Authorized Field Change

AFC 19903

Subject: Battery Discharge Protection System

Model: Lonestar[®], International[®] LT[®], and RH[™] Series trucks with feature code 08XJC

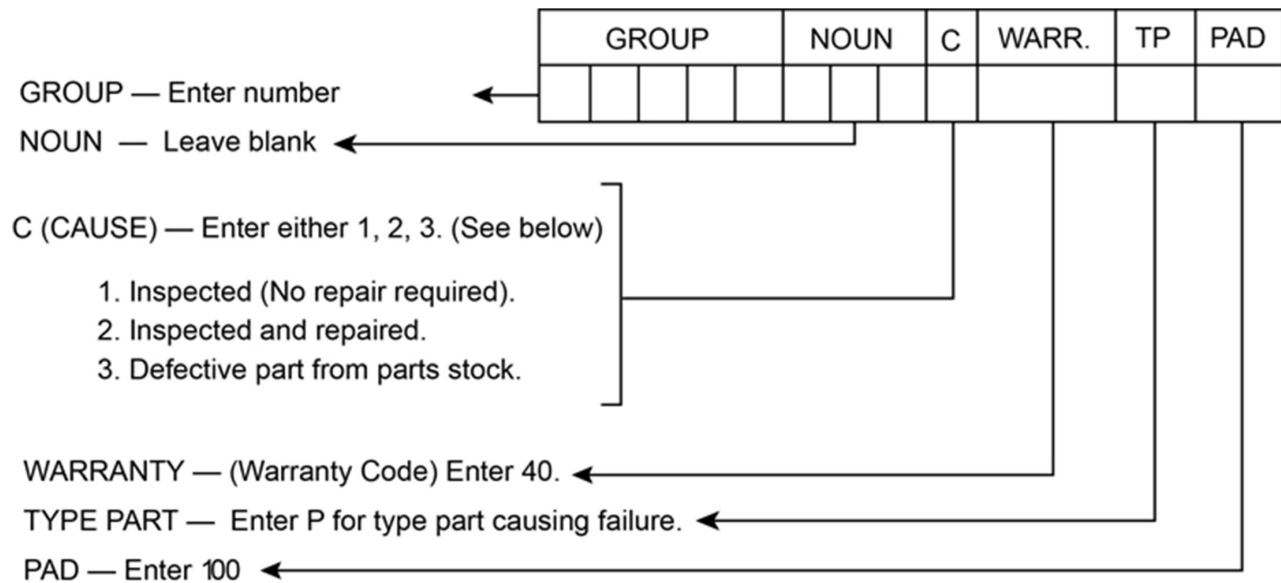
The battery discharge protection system may have an incorrect relay resulting in no battery discharge protection and no notification displayed on the instrument panel.

Part Number	Description	Quantity
4100323C1	Relay	1
